TITLE FALSE TRIGGERING OF DRIVE MOTOR			PIB NO. DK3049	
PRODUCT LINE:	TAPE DISK FORMATTER <input checked="" type="checkbox"/>	EQUIPMENT CHANGED SERVO PCBA 102811	MODEL SERIES AFFECTED D3000	EFFECTIVE DATE February 15, 1976
CLASS OF BULLETIN: <input type="checkbox"/> IMPROVEMENT <input checked="" type="checkbox"/> RETROFIT ON FAILURE <input type="checkbox"/> RETROFIT RECOMMENDED <input type="checkbox"/> SERVICE INFORMATION ONLY		ORDER PART KIT NO.	EFFECTIVITY All D3000 Disk Drives	
PURPOSE: To add filter capacitors to eliminate false triggering of drive motor, which can occur if high voltage transients are present on line voltage.				
SYMPTOMS: Emergency unloads due to disk speed errors.				
PARTS REQUIRED:

TITLE FALSE TRIGGERING OF DRIVE MOTOR

PIB NO.
DK3049

Drawing 102810, Sheet 1, zone 5C
Add C74 as shown

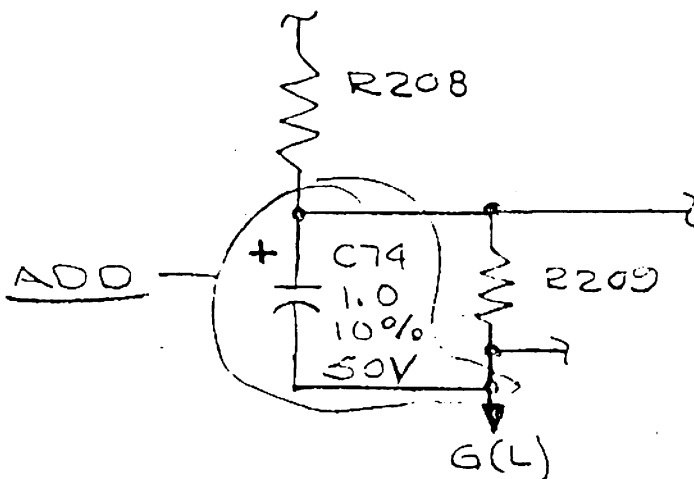
1.0 Connect one capacitor across CR34, observing polarity as shown in Figure 1. This capacitor is designated C73.				
2.0 Connect other capacitor across R209, observing polarity as shown in Figure 2. This capacitor is designated C74
